RE: **5400 Seville NW**
Grading Plan
Engineer's Stamp Date: 11/21/17
Drainage File: F11D010A

Based on the information provided in your submittal received 11/21/17 the Grading Plan is approved for SPBP. Prior to additional approvals, the following will be required:

ENGINEER'S SEAL  10/31/17 DAVID SOULE P.E. #14522	VISTAS DE LA LUZ COMMERCIAL GRADING AND DRAINAGE PLAN	DRAWN BY WCWJ DATE 10-31-17 21644-LAYOUT-1-06-17 SHEET #
	 Rio Grande Engineering 1606 CENTRAL AVENUE SE SUITE 201 ALBUQUERQUE, NM 87106 (505) 872-0999	JOB # 21644

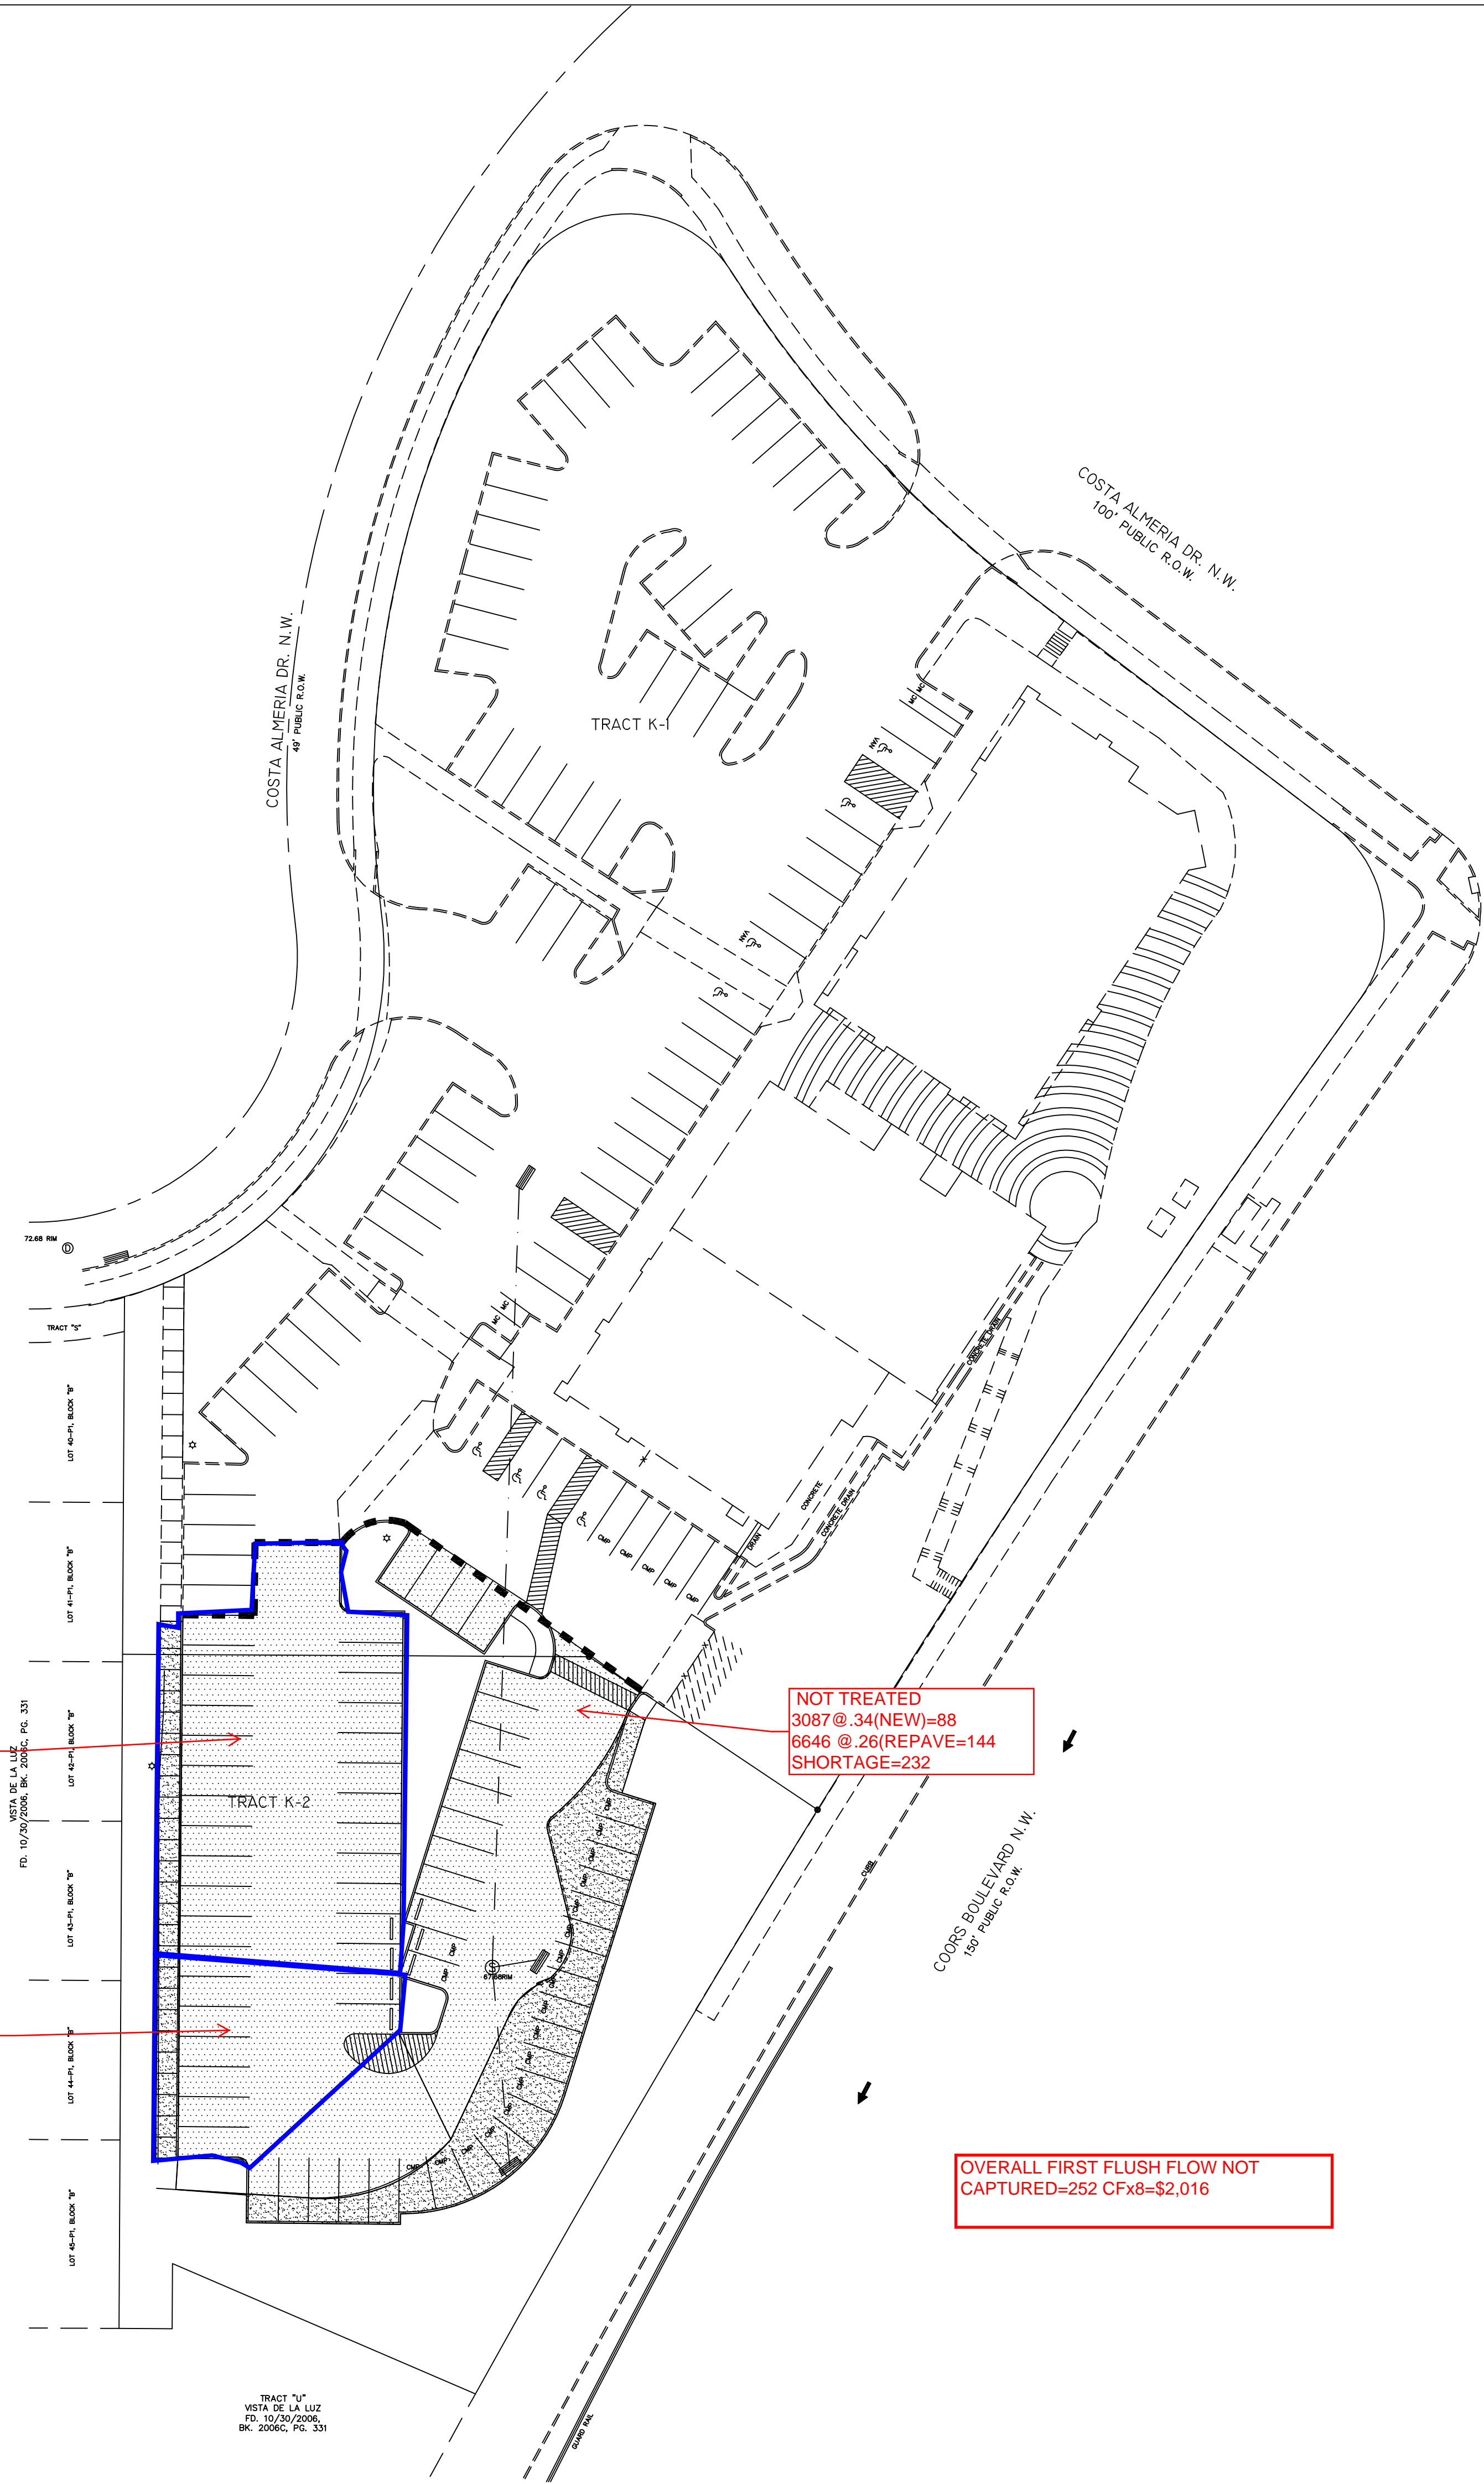
1. A Bernalillo County Recorded Private Facility Drainage Covenant is required for the stormwater quality ponds. The original notarized forms, exhibits, and recording fee (\$25, payable to City of Albuquerque) must be turned into DRC (4th, Plaza del Sol) for routing. Please contact Charlotte LaBadie (clabadie@cabq.gov, 924-3996) or Madeline Carruthers (mtafoya@cabq.gov, 924-3997) regarding the routing and recording process for covenants.
2. Payment of the Fee in Lieu (Amount = \$2,016) for the first flush volume not captured must be made and a receipt provided with the Grading Permit set.
